Product Change Notification / SYST-24YYJU400

ERRATA - AVR128DB28/32/48/64 Silicon Errata and Data Sheet Clarifications Errata Document Revision

AVR128DB28/32/48/64

Silicon Errata and Data Sheet Clarifications

Figure 34-1. DAC Block Diagram

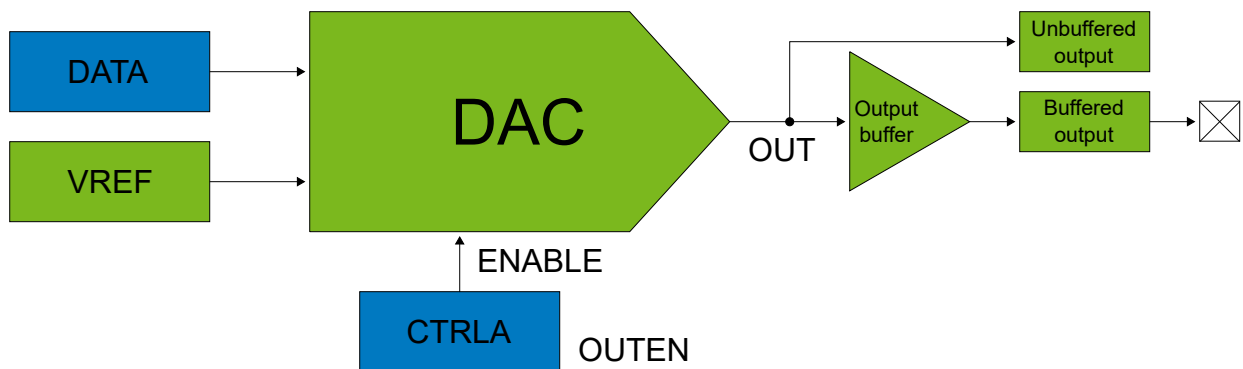
Clarifications of the block diagram and the DAC Output sub-section of the DAC peripheral has been made:

1. The block diagram is updated with clarifications to the output signal routing (buffered/unbuffered) and will replace the original block diagram.
2. Sections 34.3.2.3 (DAC as Source For Internal Peripherals) and 34.3.2.4 (DAC Output on Pin) are replaced by section 34.3.2.3 DAC Output.

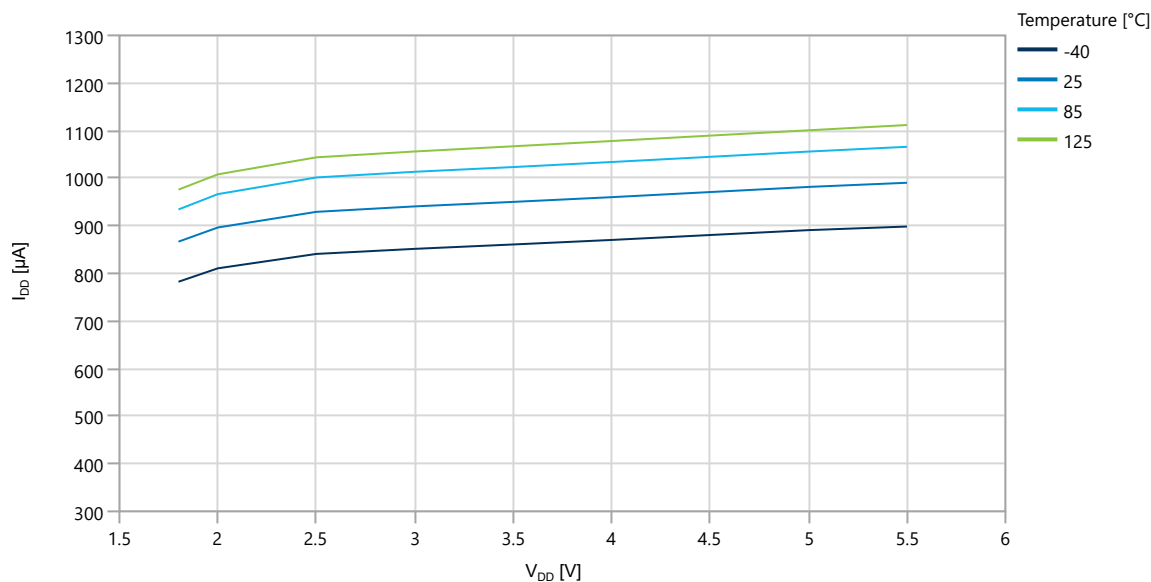
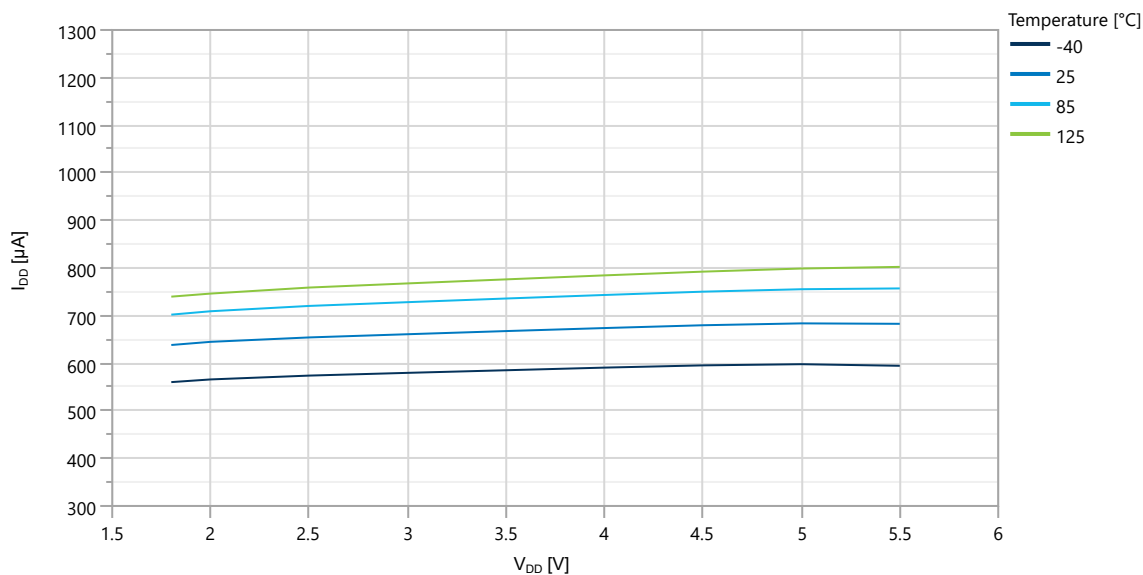
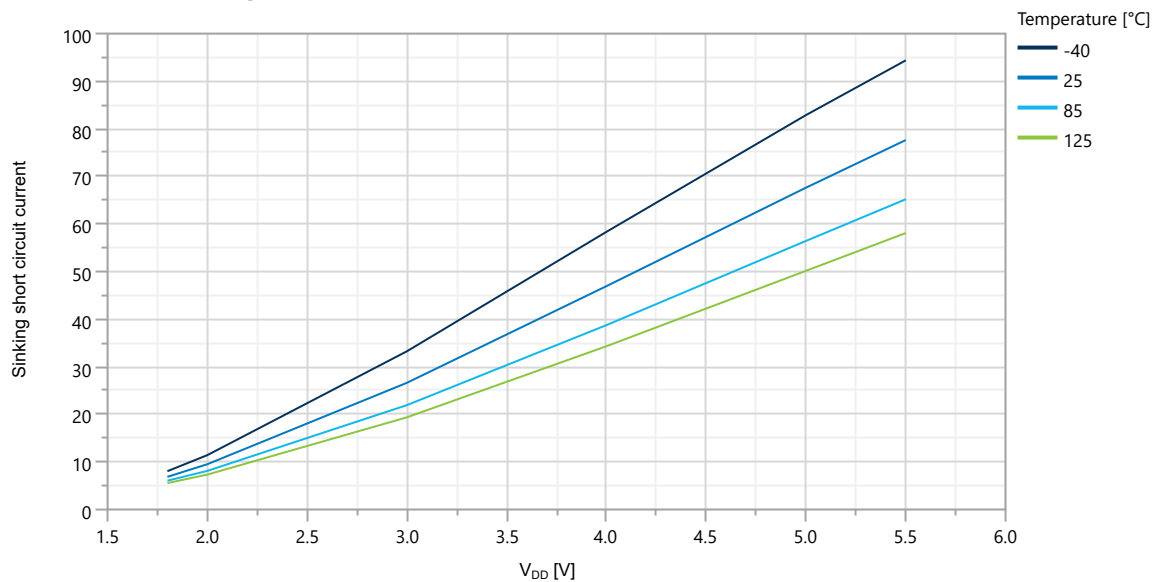
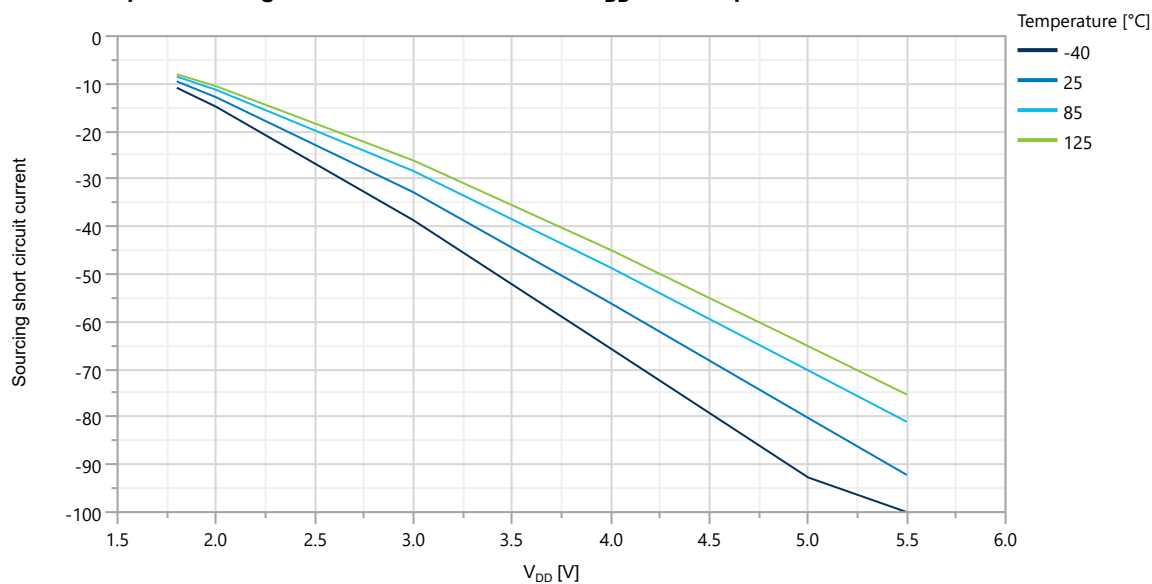
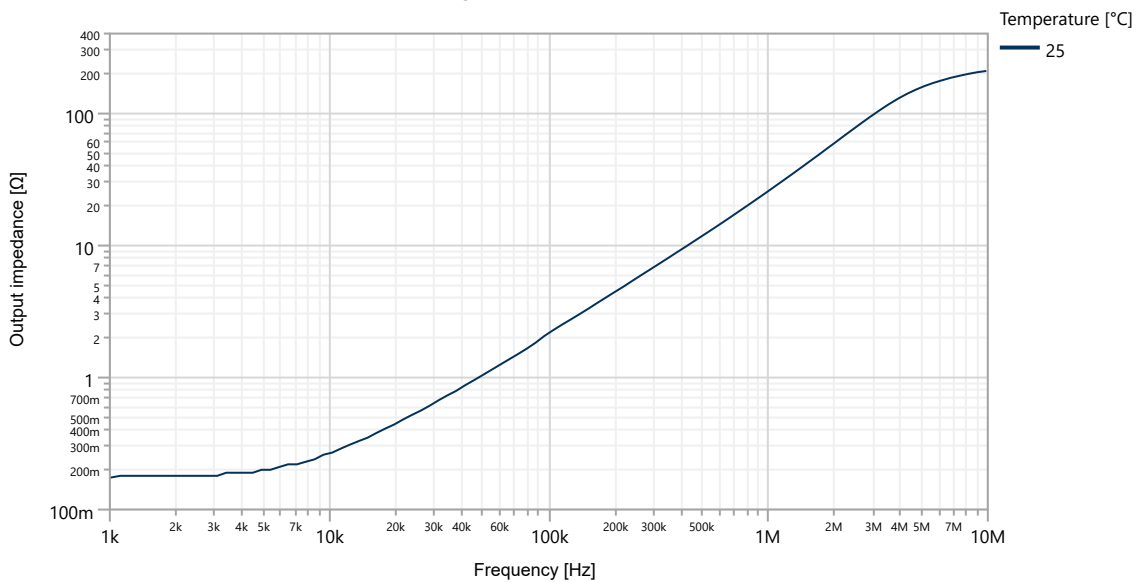
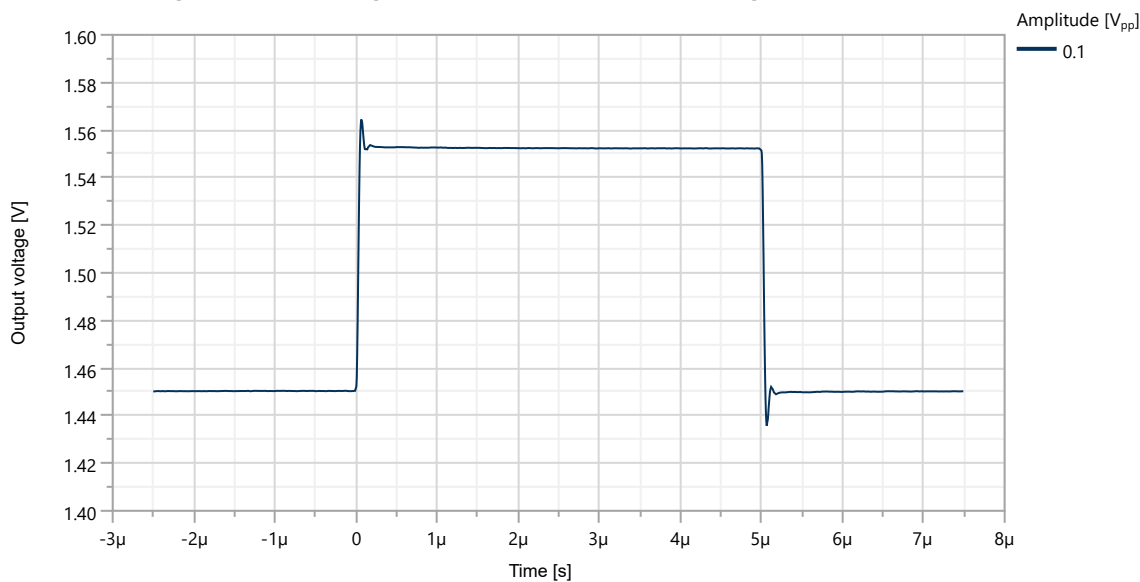
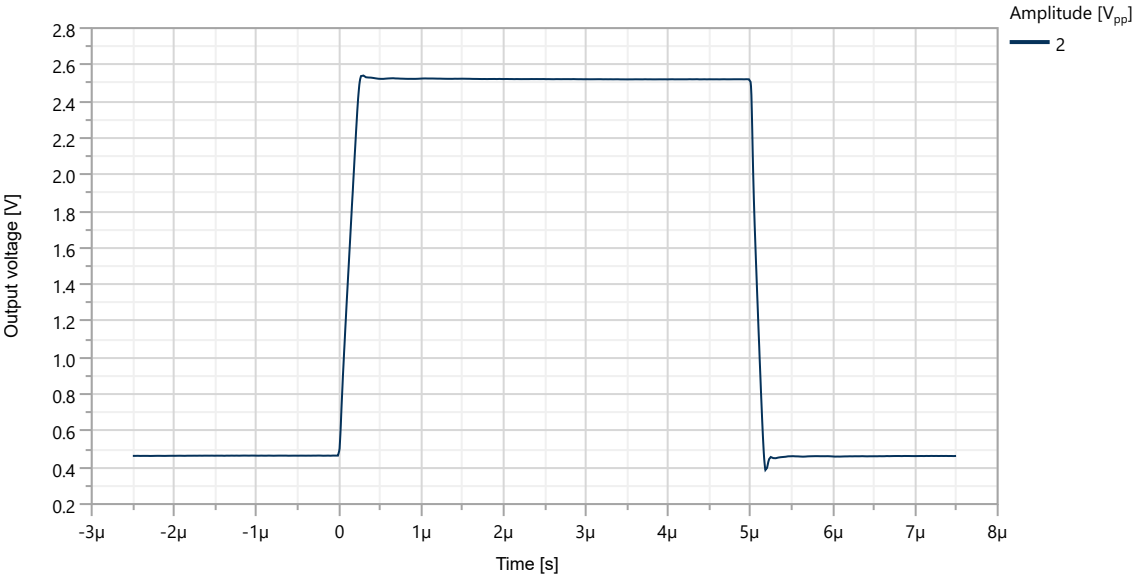
Some additional plots are added to the OPAMP section of the Typical Characteristics:

- I_{DD} over V_{DD} and temperature with IRSEL = 0
- I_{DD} over V_{DD} and temperature with IRSEL = 1
- Output sinking short-circuit current over V_{DD} and temperature
- Output sourcing short-circuit current over V_{DD} and temperature
- Output impedance over frequency at 3V and 25°C
- Small-signal non-inverting pulse response at 3V V_{DD}
- Large-signal non-inverting pulse response at 3V V_{DD}
